**RE: Take 5 Car Wash  
9601 Sage Rd. SW  
Grading and Drainage Plans  
Engineer's Stamp Date: 02/09/23  
Hydrology File: M09D035**

RE: Take 5 Car Wash  
9601 Sage Rd. SW  
Grading Plan  
Engineer's Stamp Date: 2/9/2023  
Hydrology File: M09D035

# TAKE 5 CAR WASH

## GRADING PLAN

C-4.0

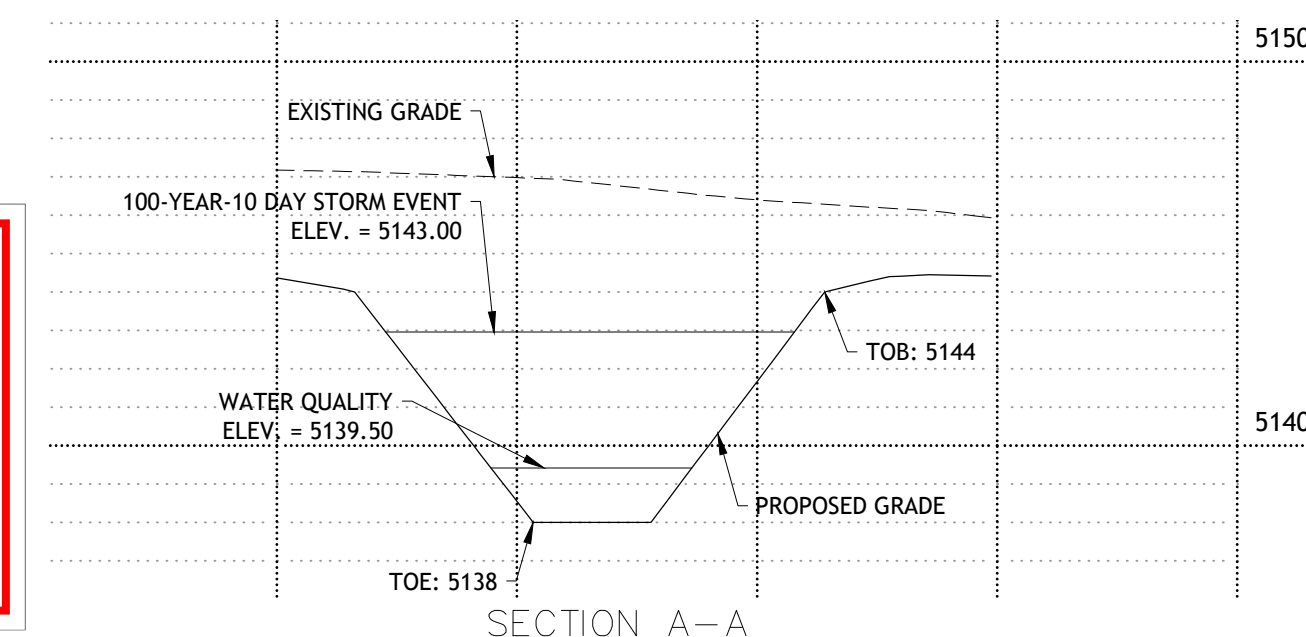
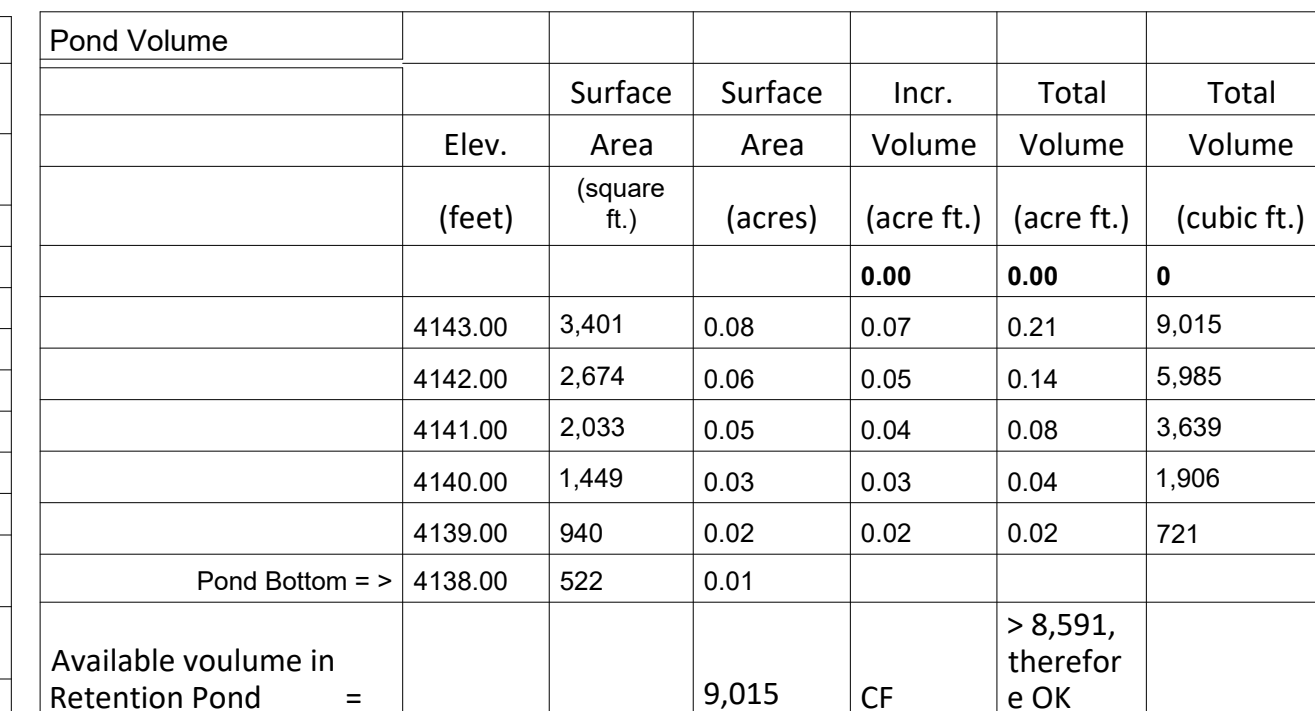
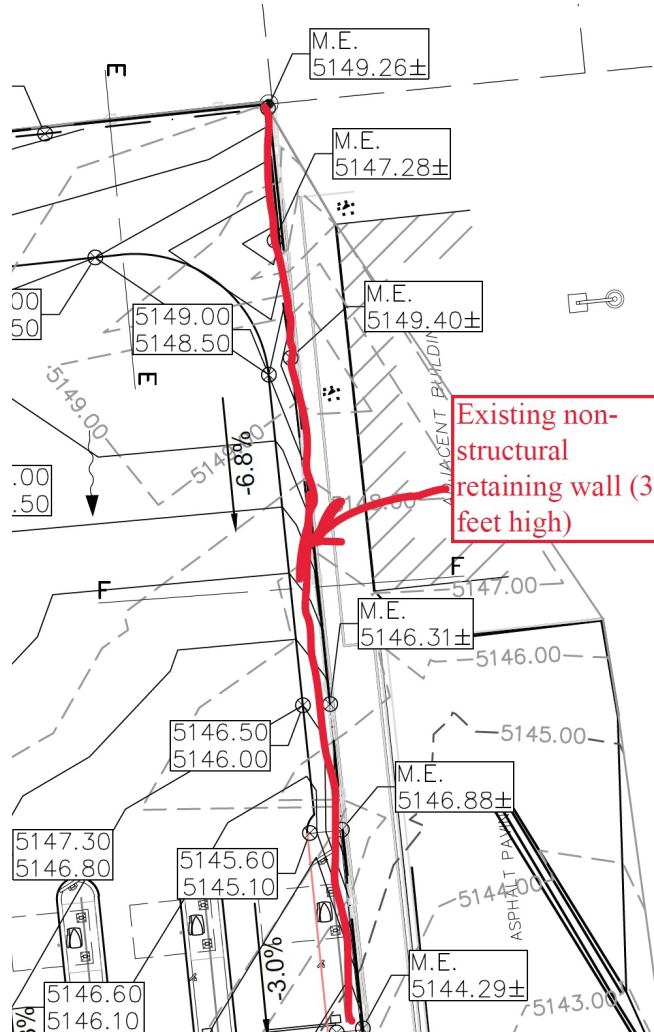
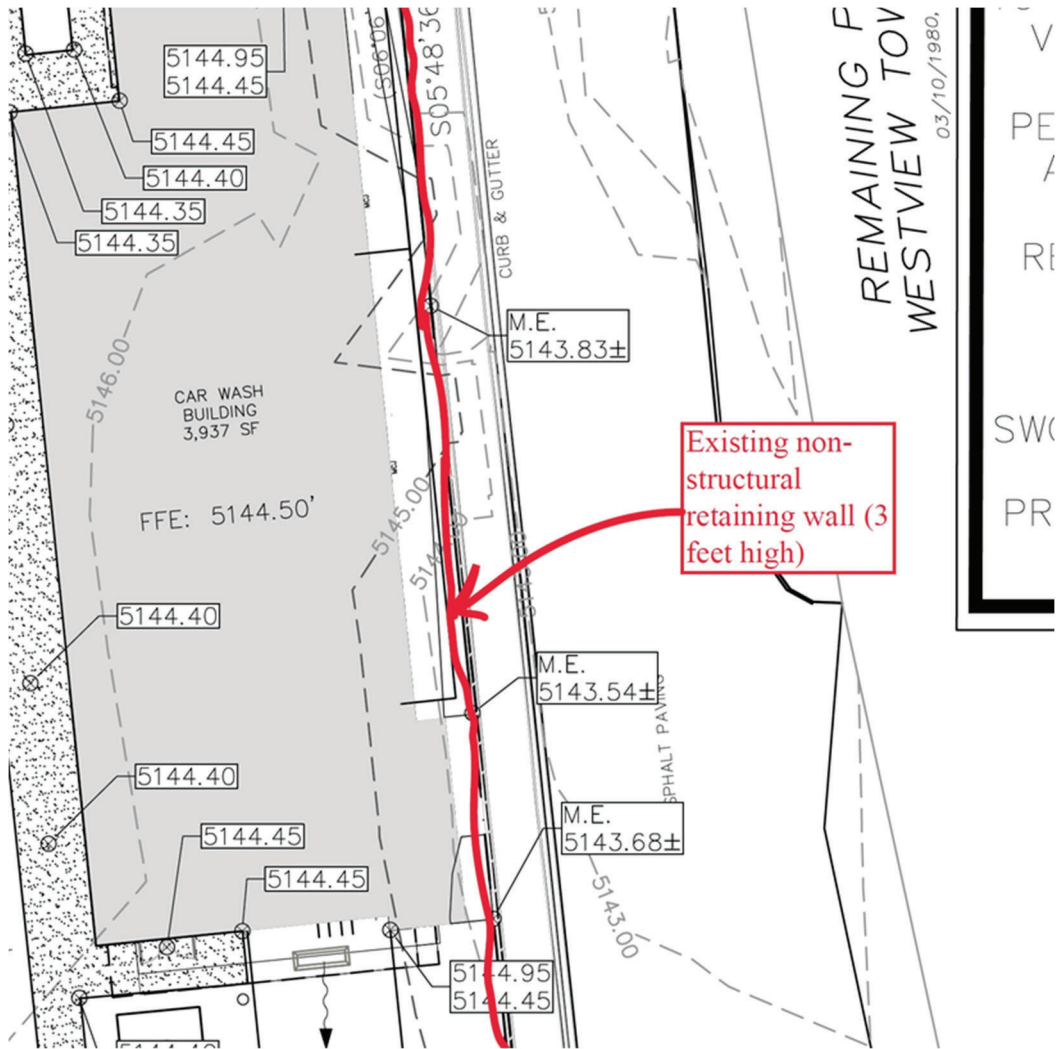
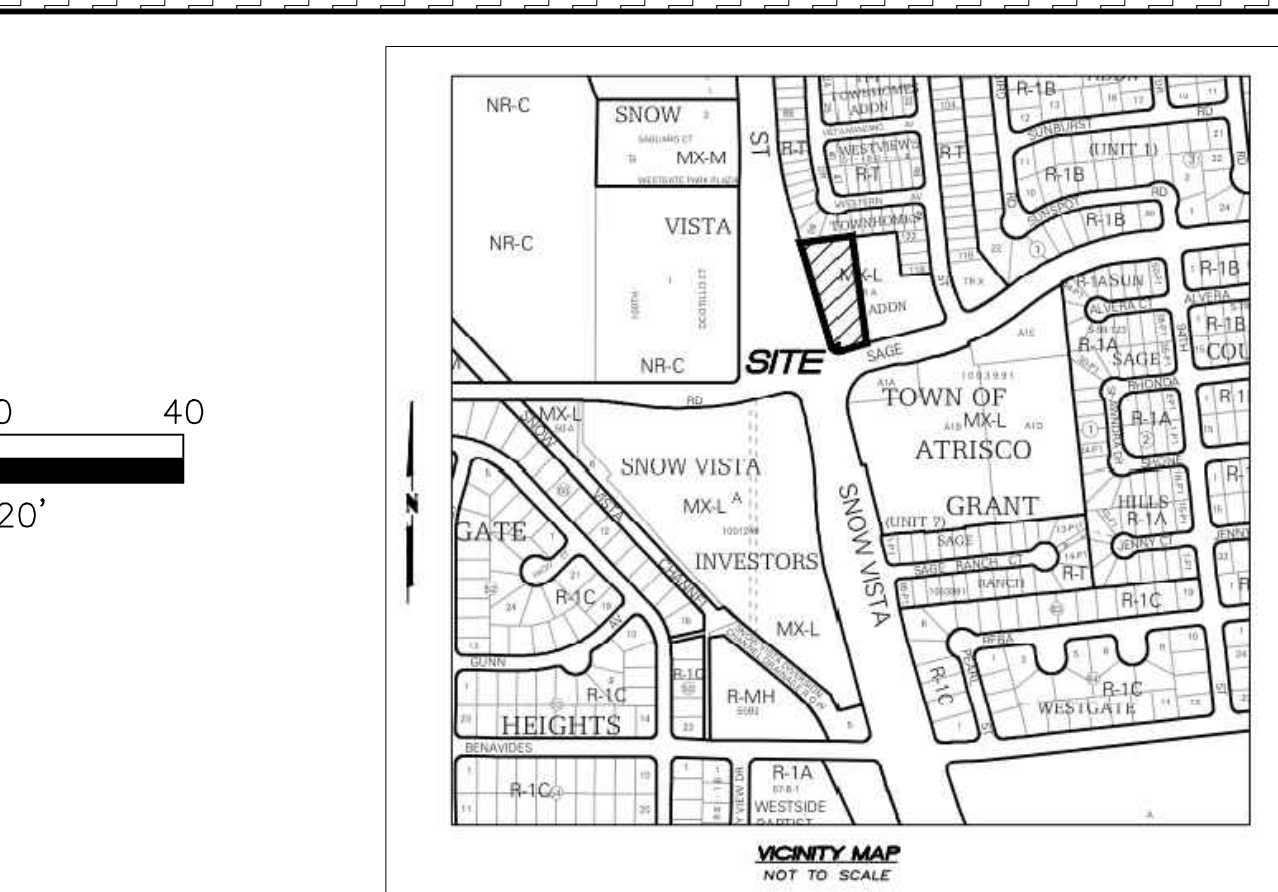
- d. Please provide a legal Description of the property. **(Provided)**
3. This site is within the Amole-Hubbell Drainage Master Plan. Specifically, it is in Drainage Area TS206. This site was to go into the existing detention pond TS2. However, after reviewing the design of this pond, there is no capacity for this development and connecting to the existing storm drain along 98<sup>th</sup> Street is not allowed. No increased runoff to overcapacity systems can be authorized per § 14-5-2-12 (G) of the Albuquerque Code of Ordinances. Therefore, this development will have to provide a retention pond (100 year -

10 day volume) as outlined in Section 6-11(A)(2) Retention Ponds in the DPM. Please note that the required SWQ requirement is within this retention pond volume.

4. Please provide an emergency spillway for the retention pond. This spillway can be a sidewalk culvert at the retention pond water surface elevation at the pond and the existing gutter elevation on Sage Road.

5. Please provide a cross section for the retention pond showing the top of pond, bottom of pond, and the required retention water surface elevation. Please make sure that there is a one-foot freeboard. Add a note, "Side slopes need to be stabilized with Native Grass Seed (per City Spec 1012) with Aggregate Mulch or equal (Must satisfy the "Final Stabilization criteria" CGP 2.2.14.b.)".

6. Please add the volume provided under the Stormwater Quality Calculations.

7. Please reference City of Albuquerque standard detail No. 2236 – Sidewalk Culvert with Steel Plate Top at the sidewalk culvert. Also, please provide the weir calculations, per DPM Article 6-16(A), for the curb cuts and sidewalk culverts. A coefficient of 2.7 is typically used for the weir equation  $Q = CLH^{2/3}$ .

8. A SO-19 Permit will be required for the sidewalk culvert. Please include the standard SO-19 notes on the grading plan.

9. Please use the procedure for 40 acre and smaller basins as outlined in Development Process Manual (DPM) Article 6-2(a). Please provide both the existing conditions and proposed conditions for the 100 year-6 hour storm event. These calculations should be on the Drainage Plan.

10. It appears that the proposed asphalt for the car wash and the proposed building is only about three feet from the existing three feet retaining wall (not structurally designed). Is there any proposed safety here such as adding a garden block wall so that vehicles do not drive over this onto the adjacent property which is below?

**Response:** Retention pond calculation is now provided on sheet C-4.0

**Response:** Spillway has been added to sheet C-4.0

**Response:** A side slopes note and Cross section A-A have been added to sheet C-4.0.

**Response:** Stormwater Quality Calculations include volume provided of 1,202 CF.

**Response:** A standard detail 2236 reference has been added to sheet C-4.0, calculations are also included on the sheet.

**Response: Notes are included on Sheet C-4.0**

**Response: Calculations are now provided on sheet C-4.0**

**Response: Additional grades have been added along the east property line and a guard rail has been added.**
